RE: Stultz & Almond Drain, Lakeside Park Section 6 Arm

Re: Stultz & Almond Drain: Lakeside Park 6

SITE DEVELOPMENT PLAN
LAKESIDE PARK
SECTION SIX

STORM PLAN & PROFILES
 LAKESIDE PARK
 SECTION SIX

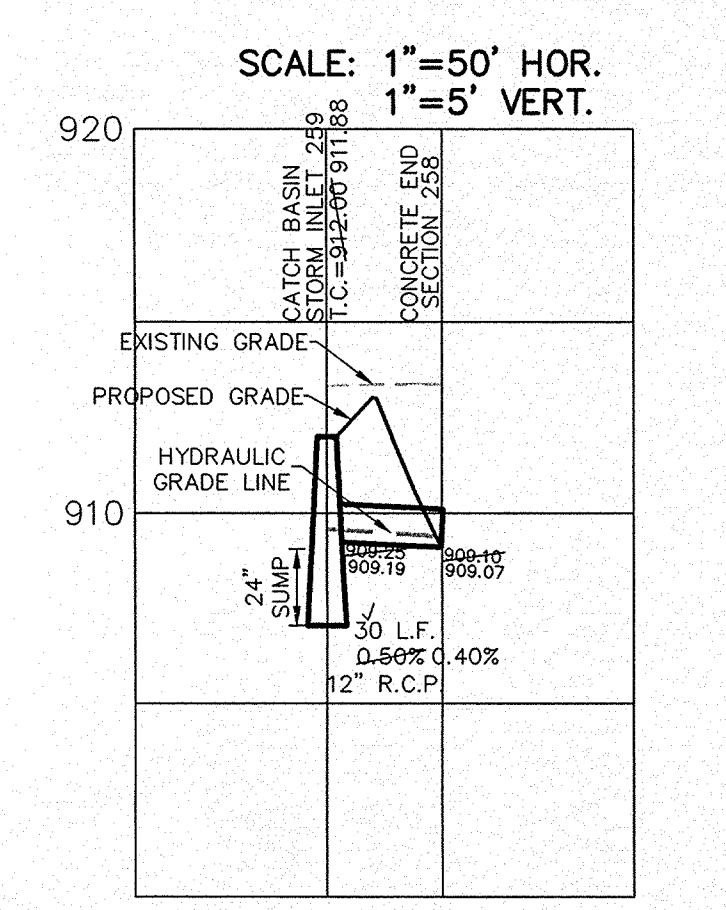
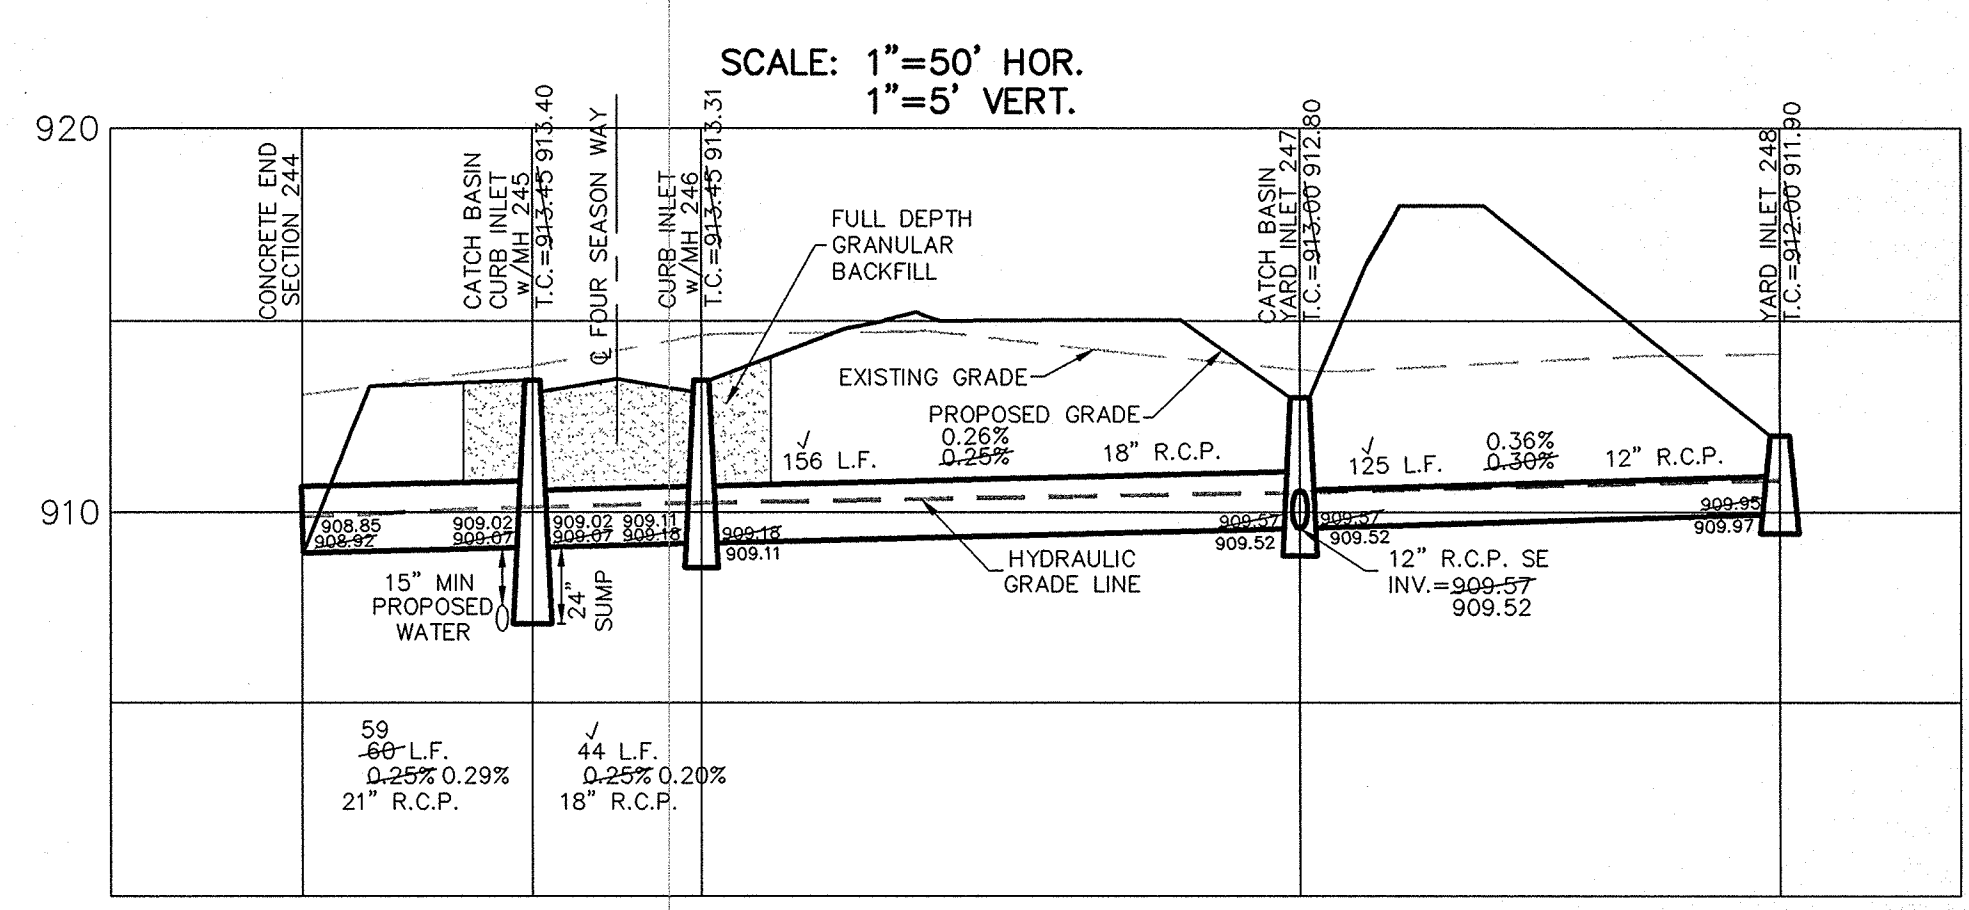
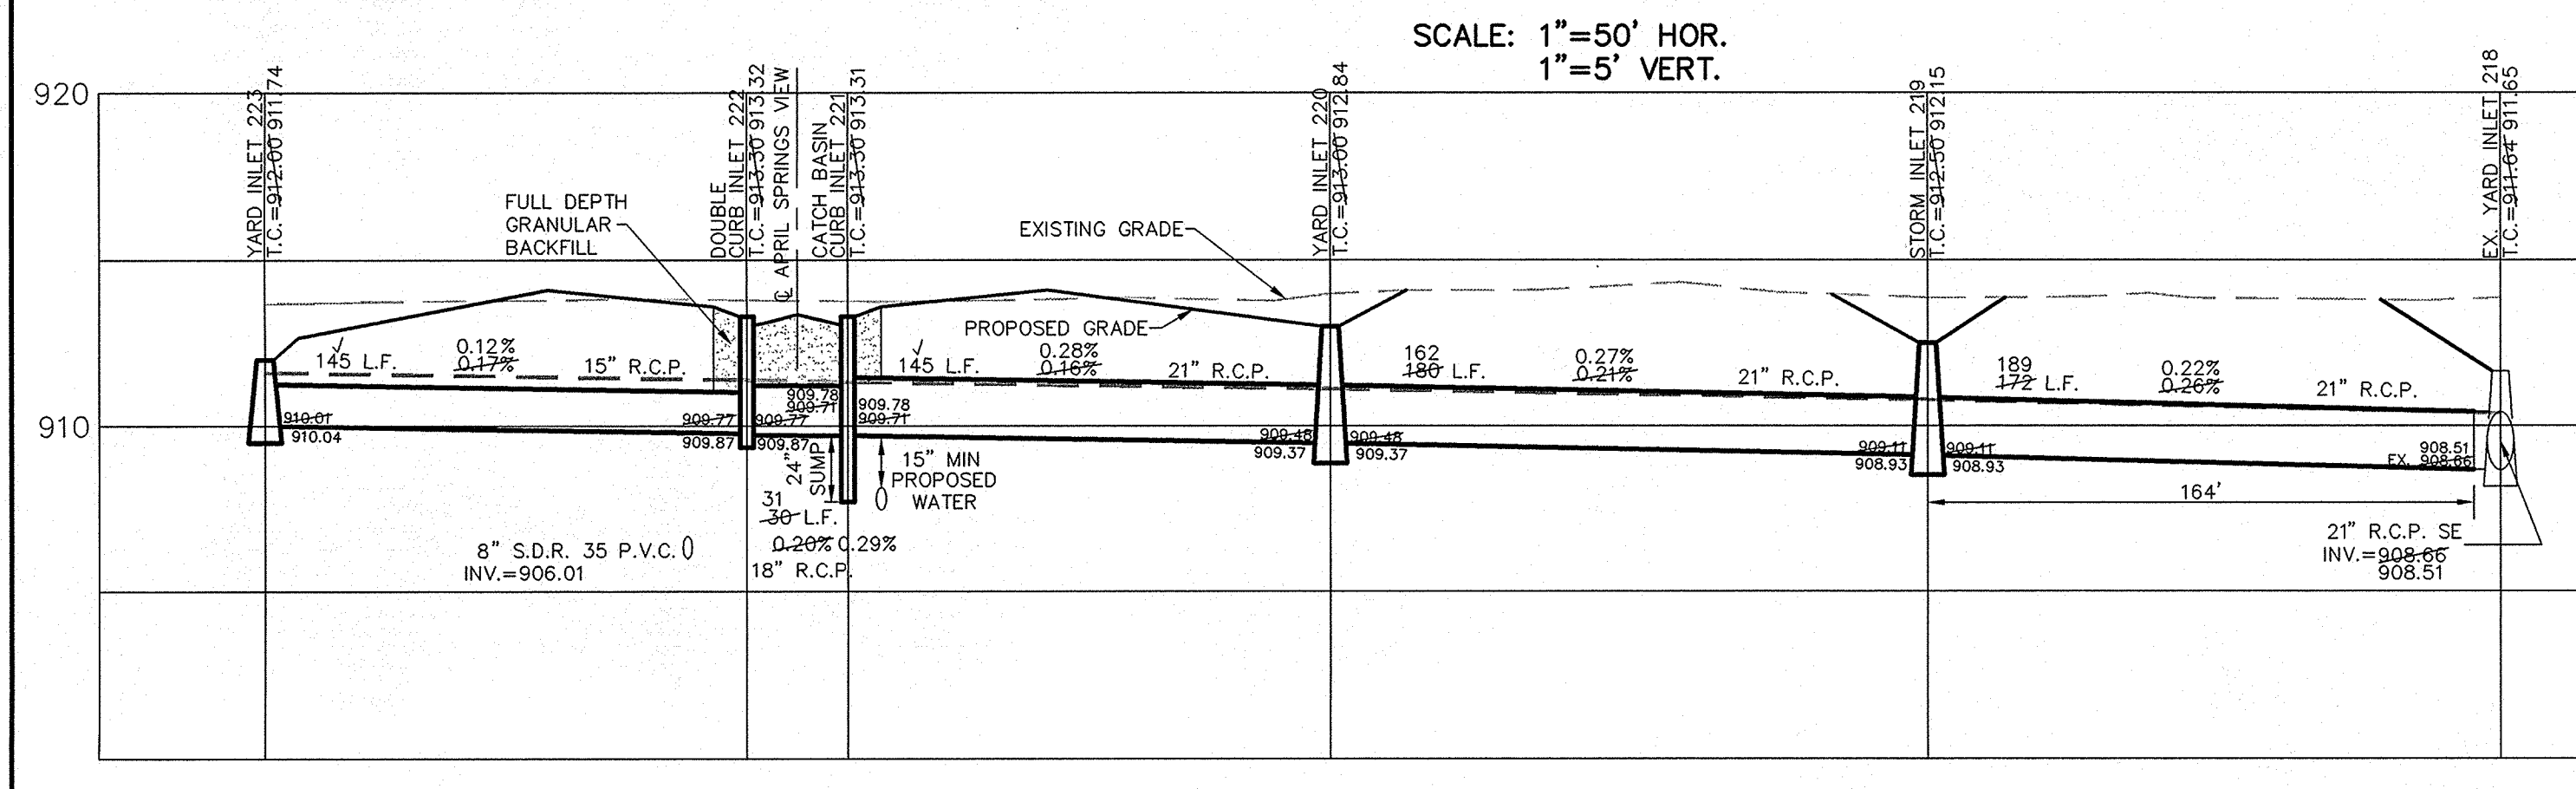
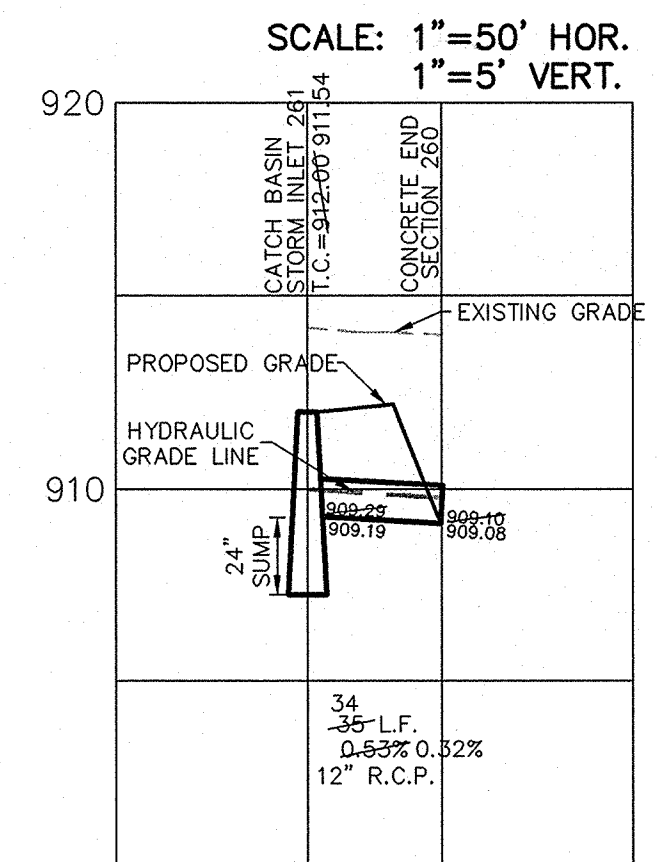
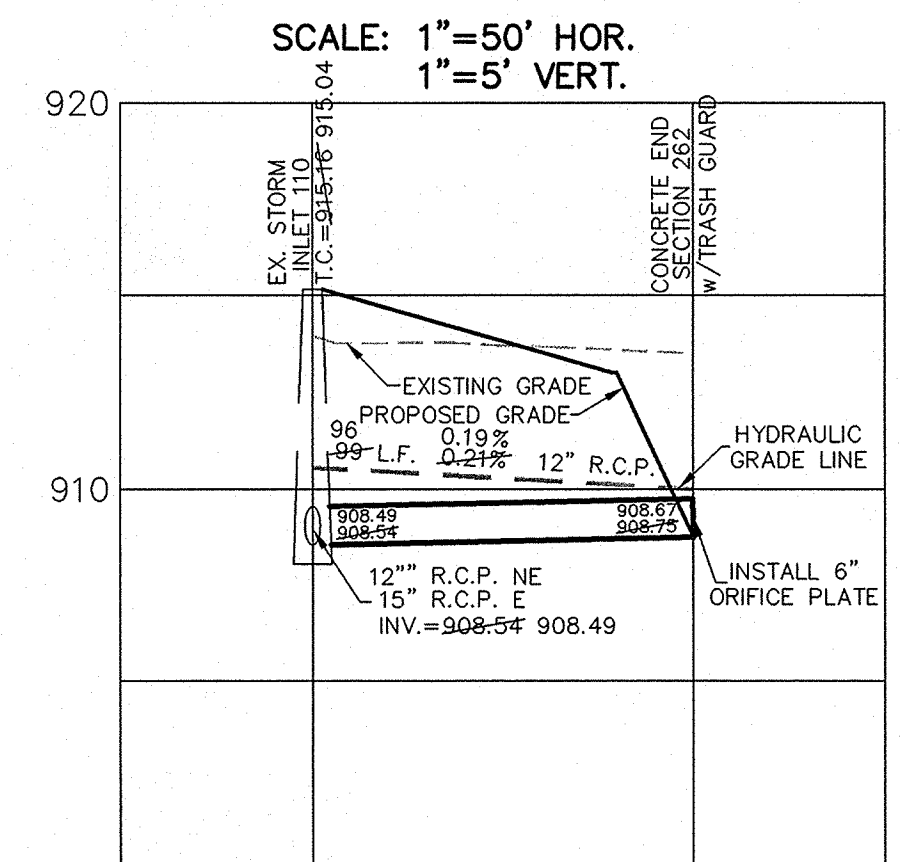
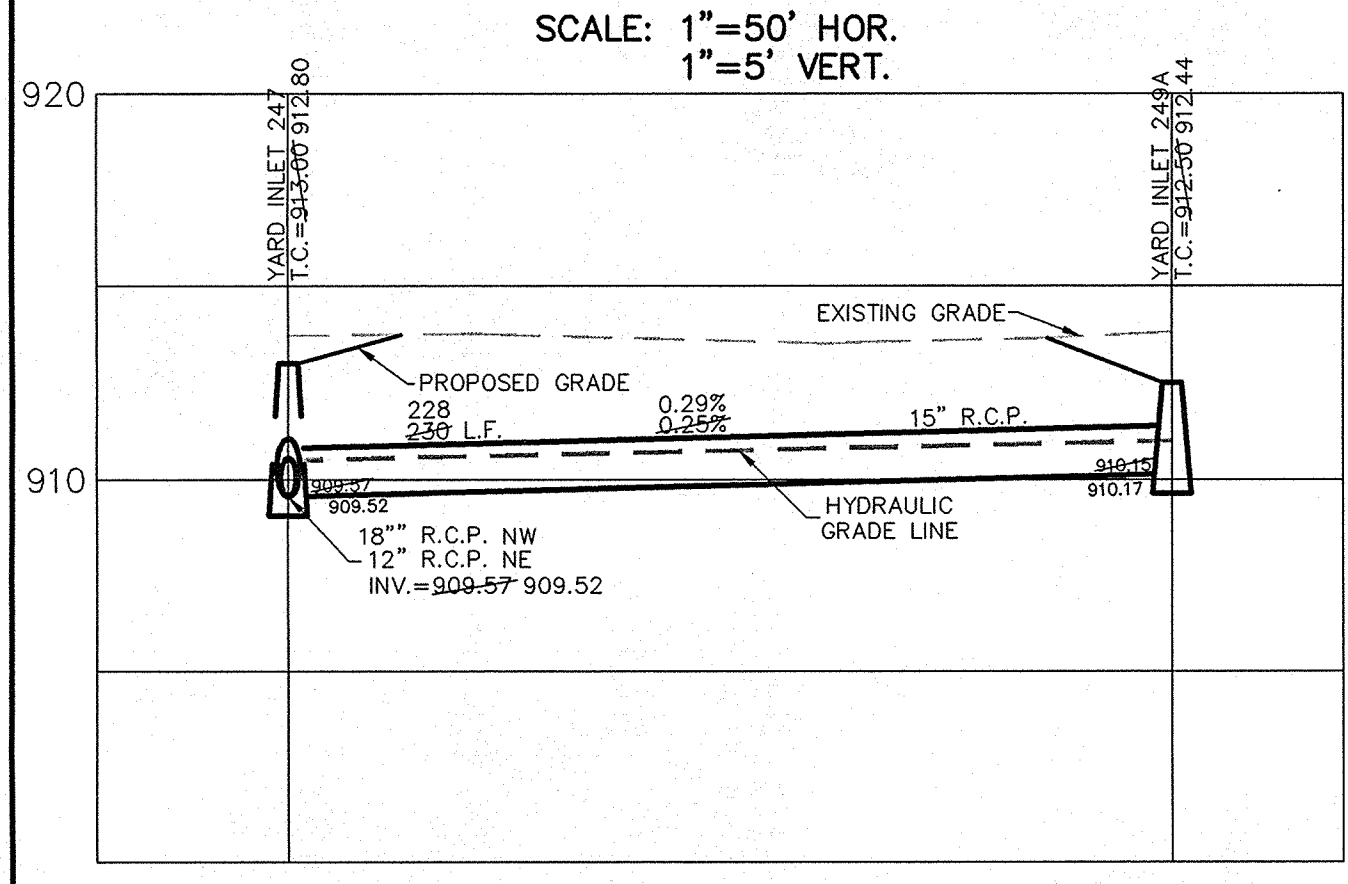
During construction, changes were made to the drain, which will alter the plans submitted with my report for this drain-dated October 17, 2007. The report was approved by the Board at the hearing held November 26, 2007. (See Drainage Board Minutes Book 10, Pages 504-505) The changes are as follows:

Structure:	Length:	Size	Material:	Up Invert:	Dn Invert	Grade:	Changes:
248-247	125	12	RCP	909.97	909.52	0.36	
247-246	156	18	RCP	909.52	909.11	0.26	
246-245	44	18	RCP	909.11	909.02	0.2	
245-244	59	21	RCP	909.02	908.85	0.29	-1
249a-247	228	15	RCP	910.17		0.29	-2
259-258	30	12	RCP	909.19	909.07	0.4	
EX110-262	96	12	RCP	908.67	908.49	0.19	-3
261-260	34	12	RCP	909.19	909.08	0.32	-1

The length of the drain due to the changes described above is now **1734 feet**.
